**Re: Application for Site Plan Approval at 657 Saw Mill River Road  
(a/k/a Parcel No. 6.50-35 Lots 8, 9, 10, and 11)**

We are pleased to provide responses to the Village Consultant and NYSDOT review memorandums along with Board of Trustee and public comments. A digital copy of the full submission package will be provided to the Building Department via email. Accordingly, we have provided the below materials and responses for your consideration to be discussed at the next Town Board Meeting.

**MEMO from David B. Smith of Planning & Development Advisors –  
Site Plan Review 657 Saw Mill River Road  
December 12, 2023**

Drawn: **KRM** Approved: **RJP**  
 Scale: **1" = 20'**  
 Date: **05/26/2020**  
 Project No: **18175**  
 18175-05 C-120-W06 TA-VH10r  
 Drawing No:  
**C-120**

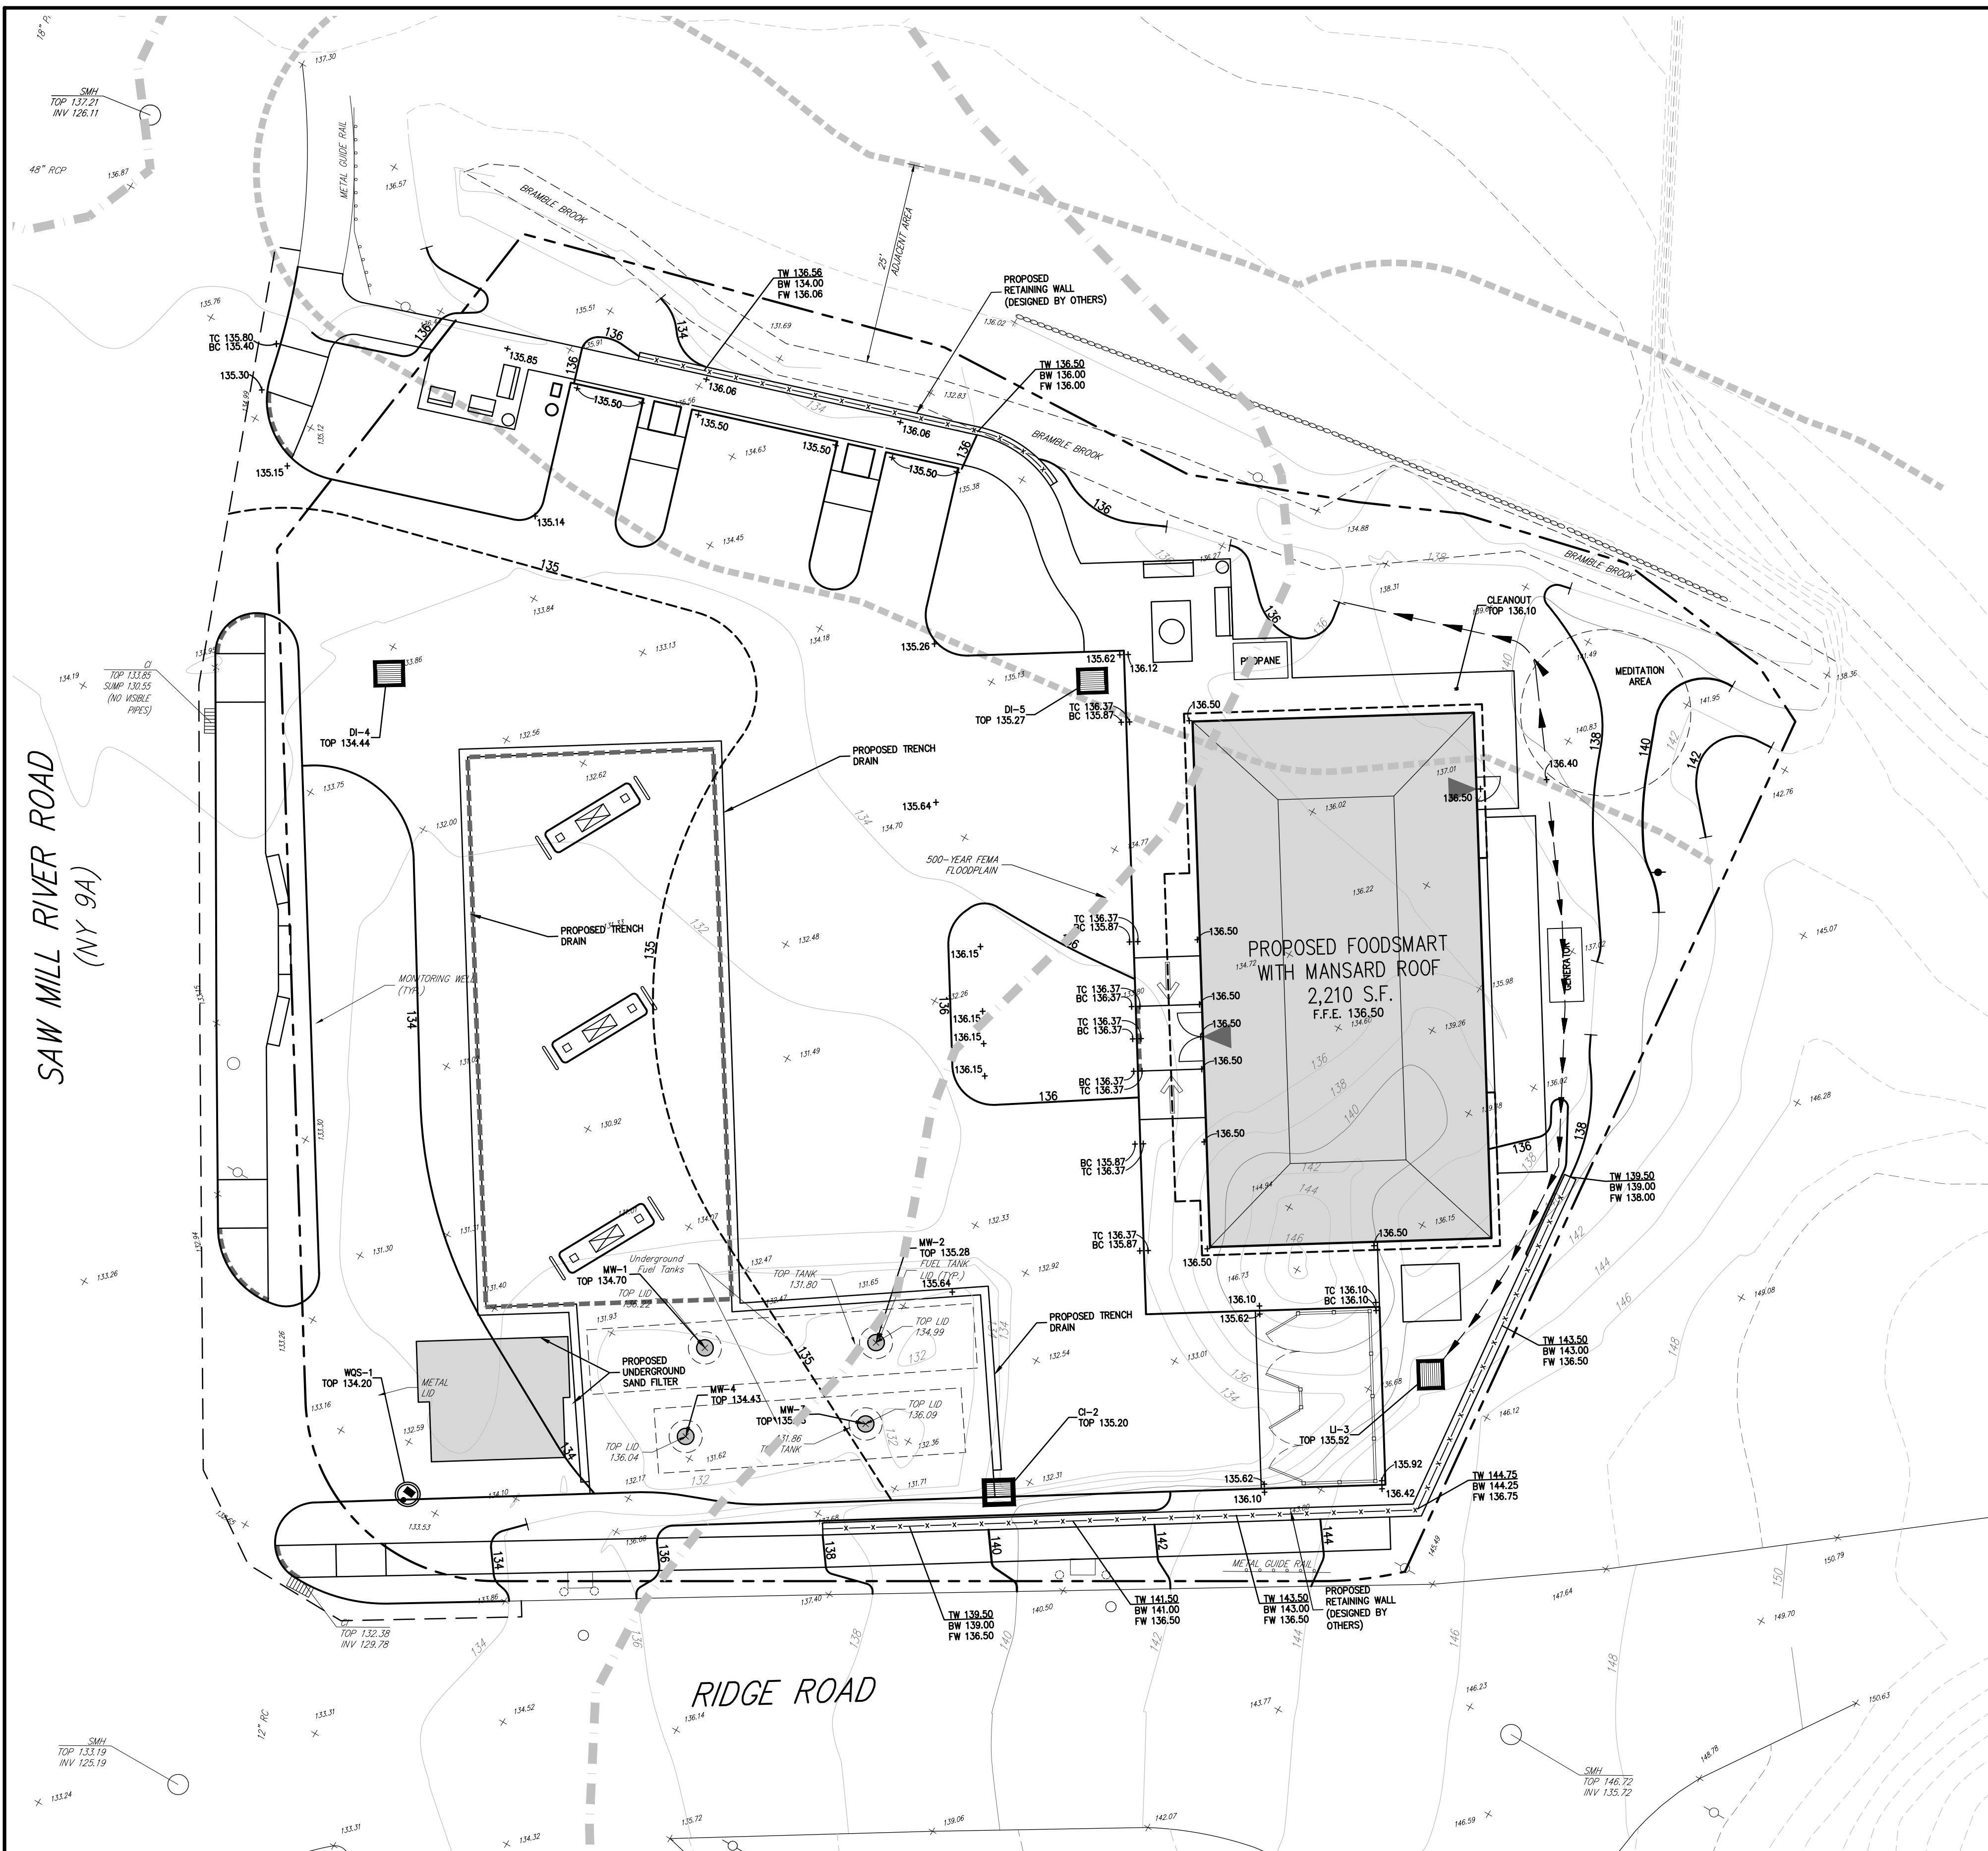
The Turning Analysis Plan also does not provide exit movements for vehicles utilizing the northern fuel island. The plan should be amended confirming that such a turning movement is obtainable.

The building has been pushed back as far as possible while still maintaining a 6' setback from the rear property line. The main drive aisle between the convenience market and the pumps has been widened by 10'. The southern driveway has been shifted south about 6.5', eliminating all previous conflicts. The need for a cobble stone paver infill and mountable curb has also been eliminated with this new proposed driveway location. Exit movements for vehicles utilizing the northern most fuel island have been added to JMC Drawing C-110 and a new JMC Drawing C-120.

Drawn: **KRM** Approved: **RJP**  
**C-200**

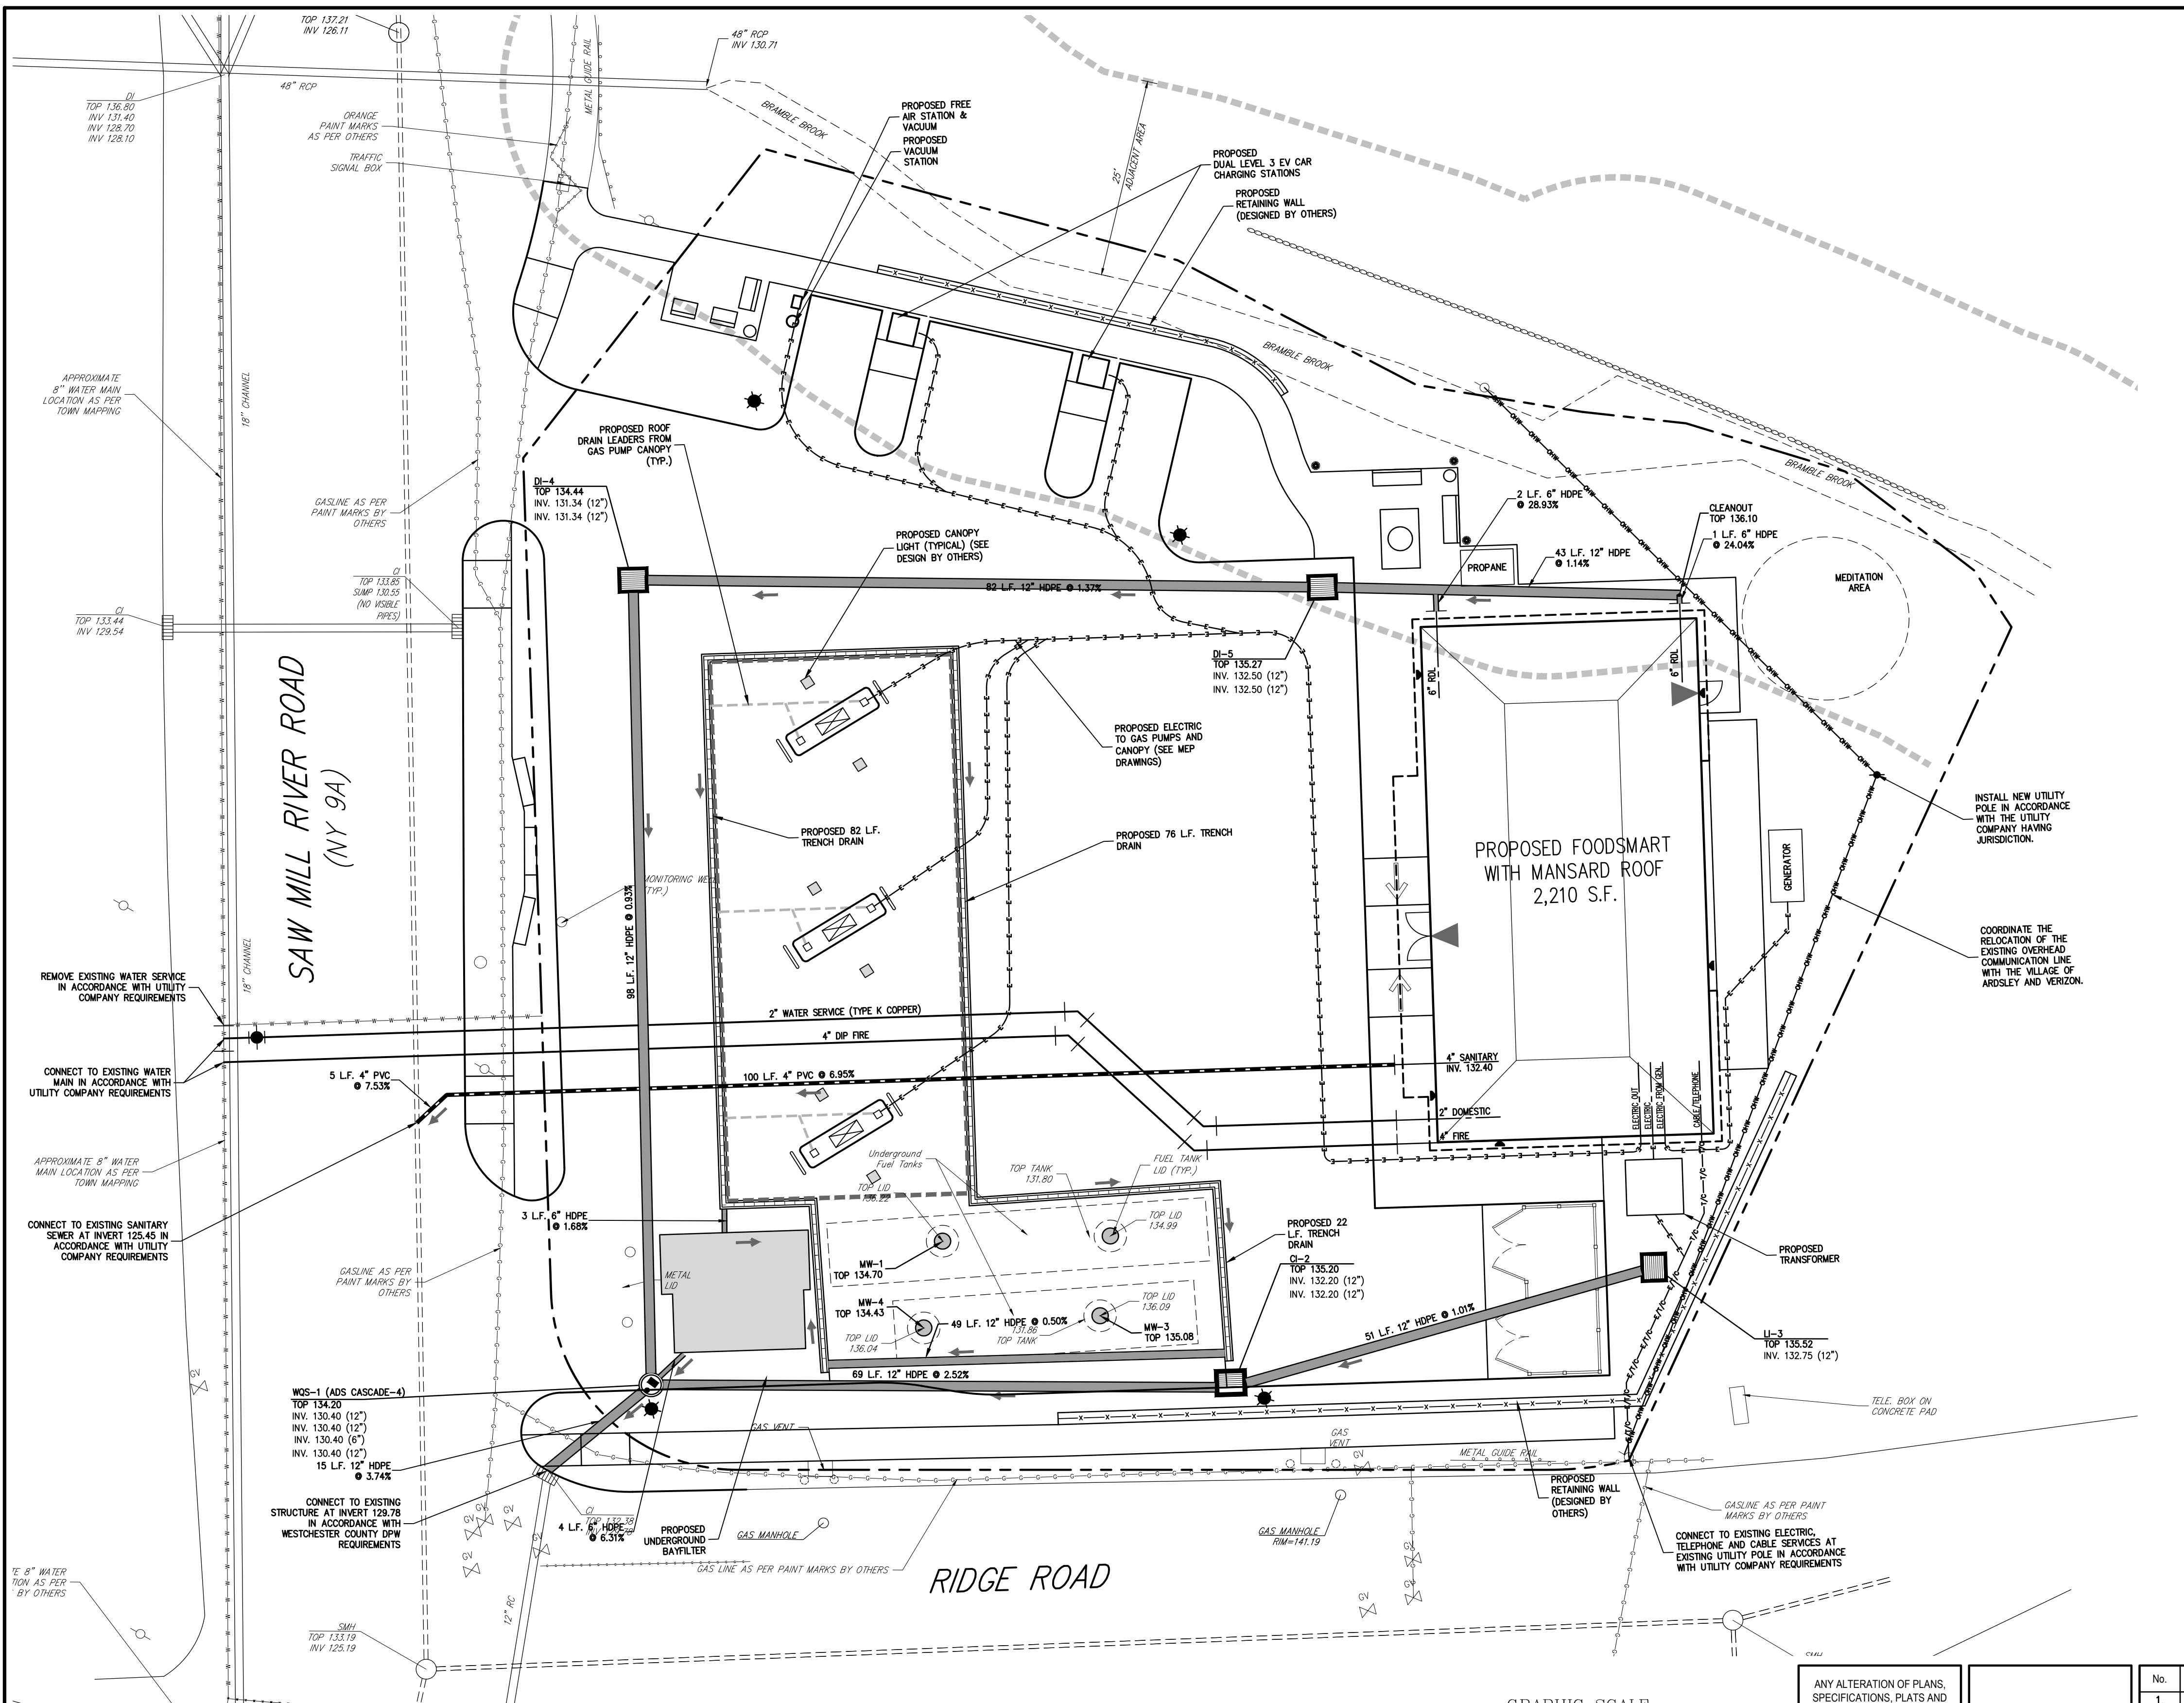
**Comment 4.** The plan shall note that the construction of all walls greater than four (4) feet in height shall be inspected and certified to their compliance with the approved design by the Design Professional prior to issuance of a Certificate of Occupancy/Completion.

**Comment 8.** A portion of the subject parcel is located within the 500-year FEMA Floodplain. The floodplain boundary should be depicted on the plan. The applicant should also note the base flood elevation (100-year) within the area of the site.

Note #6 has been added to JMC Drawing C-200 that states: "the construction of all walls greater than four (4) feet in height shall be inspected and certified to their compliance with the approved design by the Design Professional prior to issuance of a Certificate of Occupancy/Completion."

In accordance with the FEMA Flood Map (360902), the majority of the site is located within the 500-year floodplain. Also, based upon the map, no part of the site lies within the 100-year floodplain. The Base Line Flood Elevation is identified as 132.33 feet. The 500-year FEMA floodplain line has been added to the site plans and note #5 has been added to JMC Drawing C-200 identifying the base flood elevation of 132.33.
